STAFF SUBMITTAL

COMMISSION ON WATER RESOURCE MANAGEMENT

January 20, 2026
Honolulu, Hawai'i

Approval of Stream Channel Alteration Permit Application (SCAP.6438.3),
Applicant Wasatch Arete TB Holdings
Maintain Drainage Capacity and Stream Flow for New Roadway Access within
Existing Turtle Bay Resort Property,
Landowners TB H2 Holdings, LLC and North Shore Bay Owner LLC,
'Ō'io Stream (East Main Drain), Kahuku, O'ahu
TMK Nos.: (1) 5-7-001:048, 049, and 052

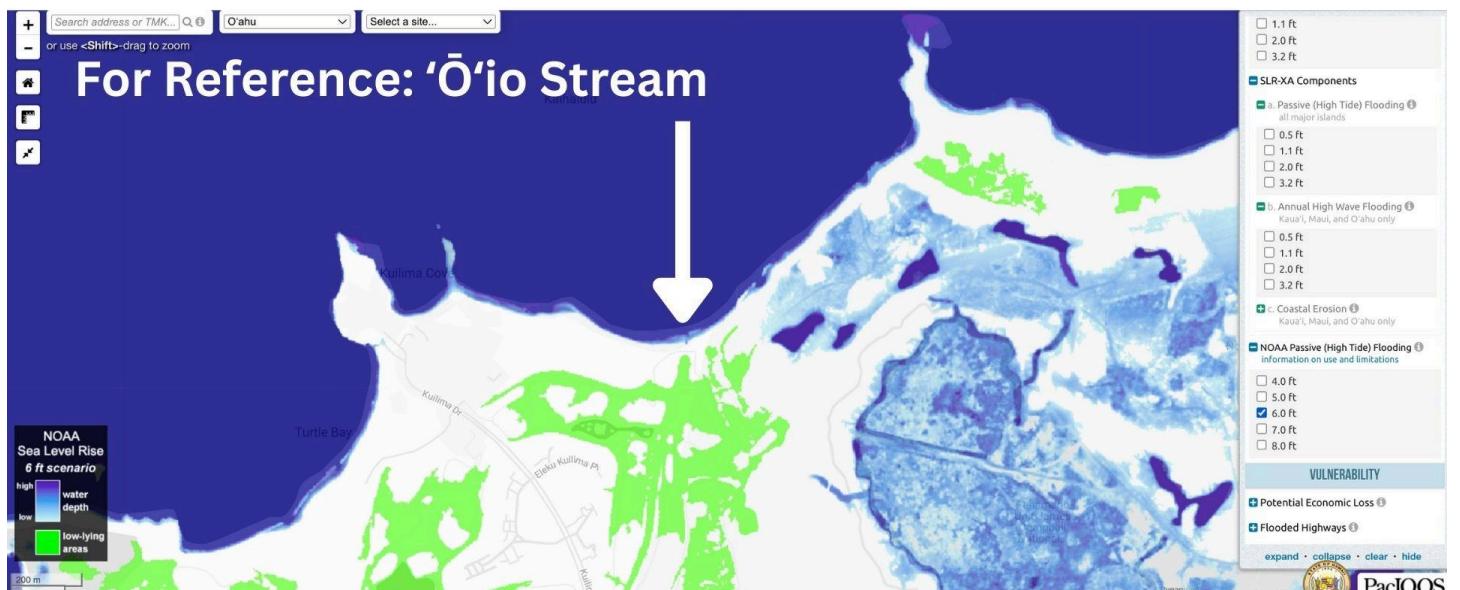
State guidance is explicit: planners and applicants must evaluate a minimum of **4 feet of sea level rise**, and up to **6 feet for low-tolerance-for-risk infrastructure**, such as culverts. NOAA's updated 4–8 foot passive flooding scenarios, PacIOPS layers, and revised SLR-XA projections were released in support of these requirements.

However, the applicant's analysis relies instead on **older “low” and “intermediate-low” scenarios** that UH researchers have already deemed obsolete. By failing to incorporate the newly released 2025 data, the applicant's modeling does not reflect current exposure conditions, projected flooding pathways, or the State's

required planning thresholds. As a result, the analysis cannot be considered aligned with best available science and cannot support responsible decision-making.

Given the accelerating pace of sea level rise and recent statewide updates to coastal hazard modeling, approving a culvert based on outdated or incomplete data would expose both the Commission and the public to unnecessary and preventable risk.

Passive High Tide Flooding at 6 Feet

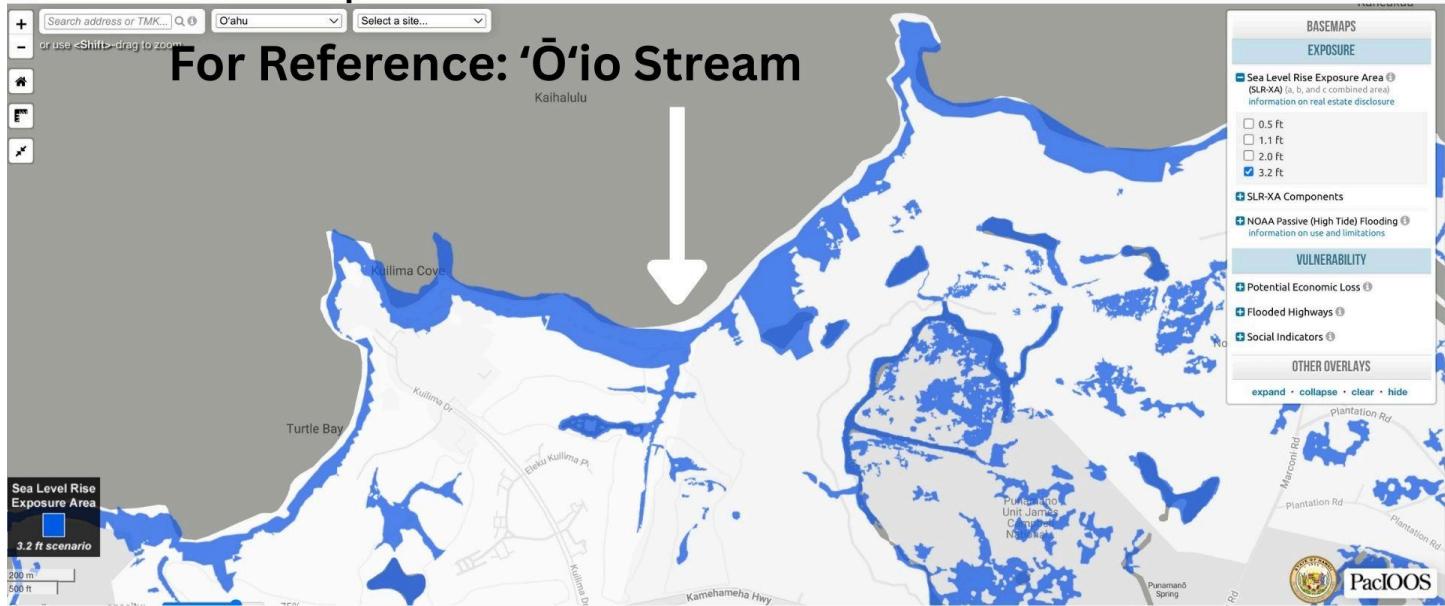
NOAA passive flooding layers from 4-8 ft – showing what high-tide flooding could look like in future conditions
